eM2 Discharge Line Interference with Equalizer

Field Service Campaign SF-712

Planned Publish Date: 3/14/2025

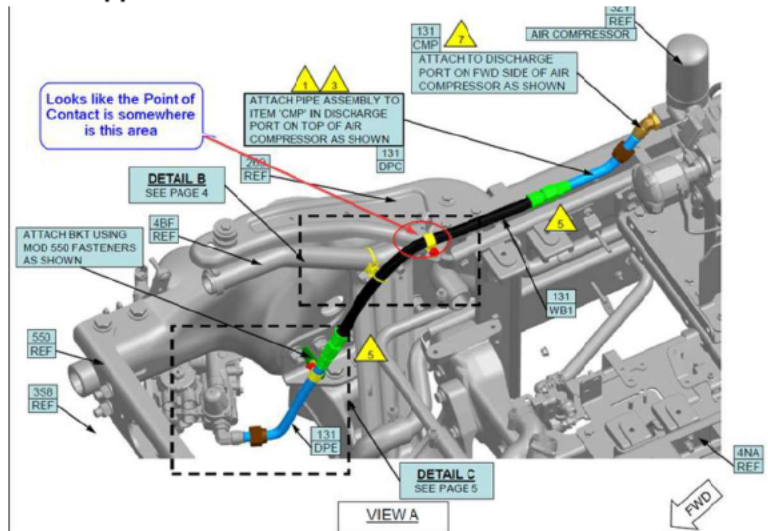
- Wirebraid hose section of air compressor discharge line may contact equalizer, and could eventually rub through

- Affected vehicles eM2 built with 131-C22306, prior to changeover of EWR P66101
- Population of affected vehicles: 107

- Issue was identified during pre-series (3/7/2022, ref Shopcall 533330 & 548997)
 - Plant, ME, and Engineering could not confirm condition was reliably corrected until 5/13/2024 changeover of P66101

- Design error

- EWR P66101 released new discharge line design with added clearance to equalizer
- Production changeover: 5/13/2024
